[NOTE: Changes in red were recommended by the Environmental Planning Commission at its hearing February 13, 2014. Numbers in brackets indicate the associated Condition of Approval from the Notice of Decision. Changes in blue are subsequent changes recommended by staff.]

WEST SIDE STRATEGIC PLAN AMENDMENT

The amendment to the West Side Strategic Plan that follows shall be inserted after page 154 of the West Side Strategic Plan, at what is currently the end of Section 3 Specific Westside Communities, to continue after Policy 3.94.

Exhibit 10, Road Network Map

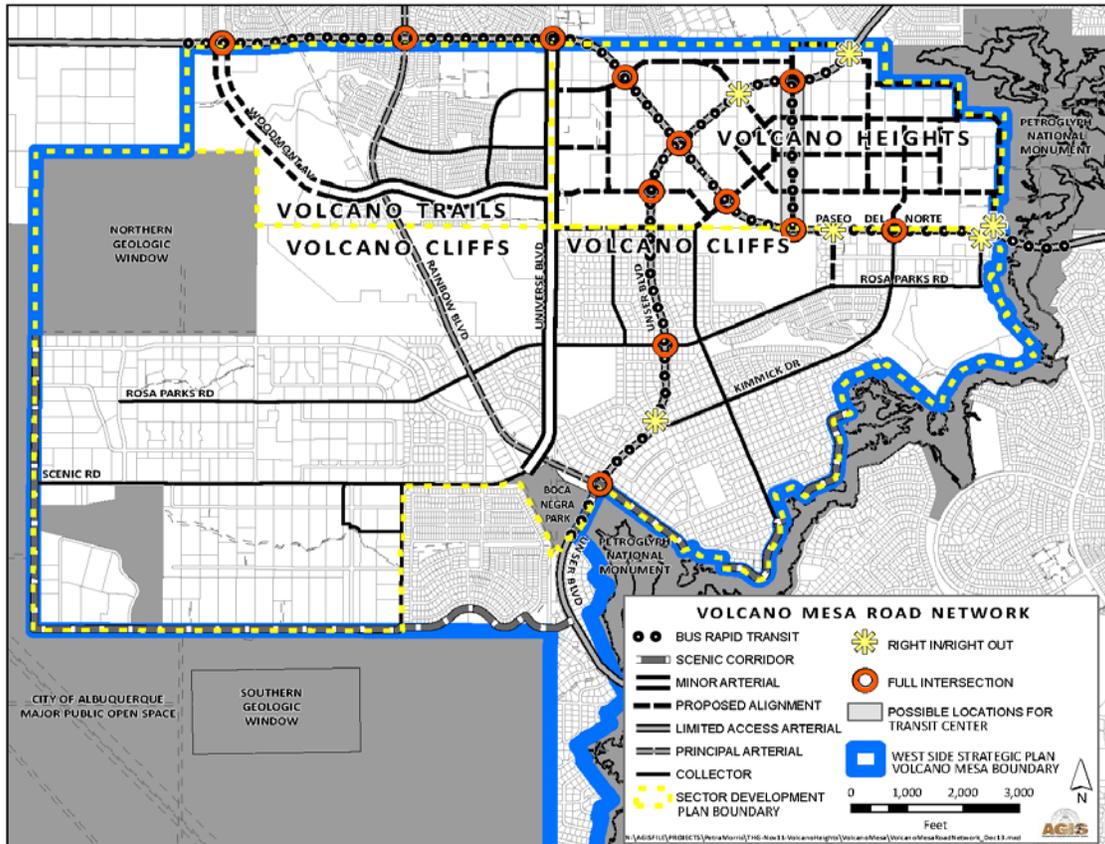
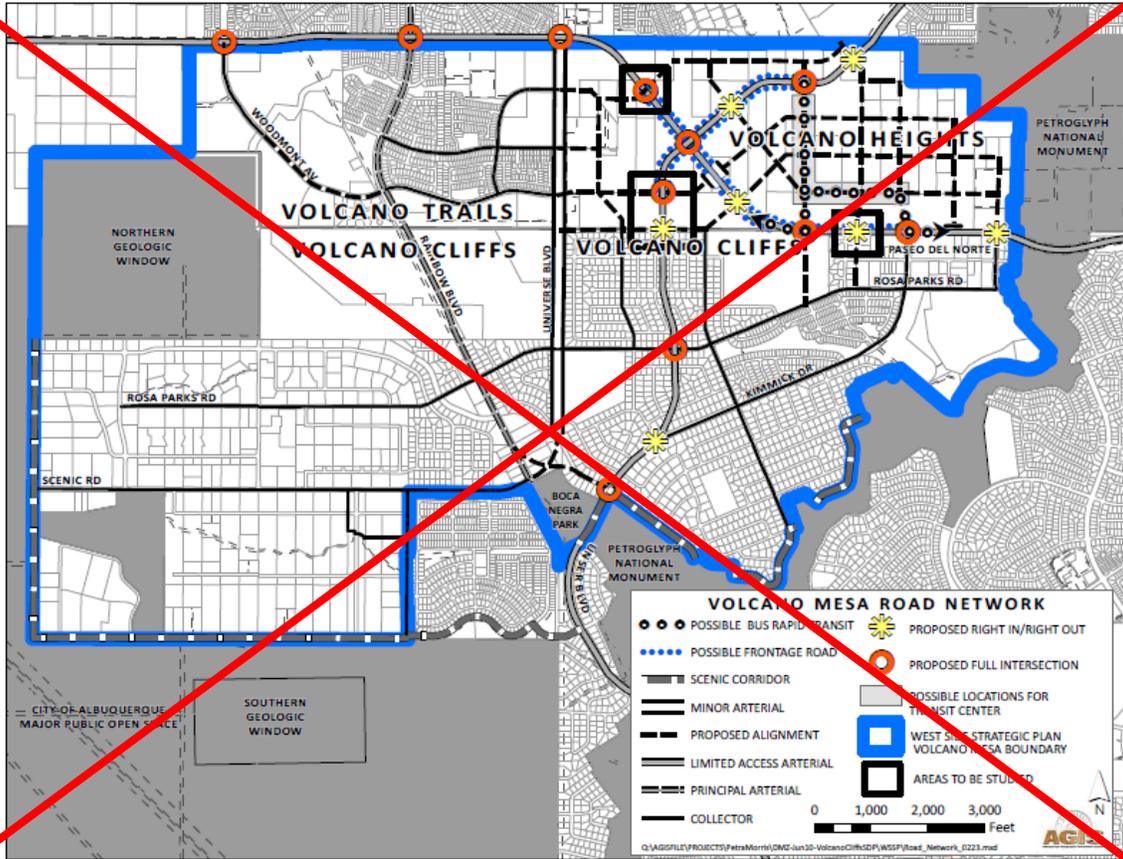
Policy 3.110 Access points on Paseo del Norte and Unser Boulevard should be limited to those shown in Exhibit 10, Road Network Map. When constructed, intersections should be carefully designed with multimodal accommodations to ensure safe access for pedestrians and cyclists to enhance the connectivity and walkability of this Major Activity Center, balanced with minimizing delay for regional through traffic.

~~The access points to Paseo Del Norte and Unser, shown in Exhibit 10, Road Network Map should be adopted.~~

~~MRCOG defines Unser and Paseo Del Norte as “limited access roadways” designed to carry high volumes of regional traffic. To maintain travel speeds, intersection spacing is restricted. However, a key component of the Roadway plan (See Exhibit 10) is the proposed access locations along Unser Blvd. and Paseo Del Norte within the Volcano Mesa area. While both roads are currently designated Limited Access Arterials, whose main function is to move traffic quickly and efficiently, these arterials must now provide access to and from adjacent neighborhoods as well as the Volcano Heights sub area in order to support the level of employment, commercial, and residential uses envisioned for the Volcano Heights Major Activity Center. The proposed access points, both full and right-in/ right-out, provide essential connections into and within the Volcano Mesa area and form the basis of the area’s internal network. In addition, the proposed access points facilitate access to transit and the proposed Transit Center located in the Volcano Heights sub area. Proposed access points are shown on the Roadway plan, these access locations are generally located to provide optimal connections to, from, and within the Volcano Mesa area and the Volcano Cliffs sub area. [4]~~

[5, 6, 7]
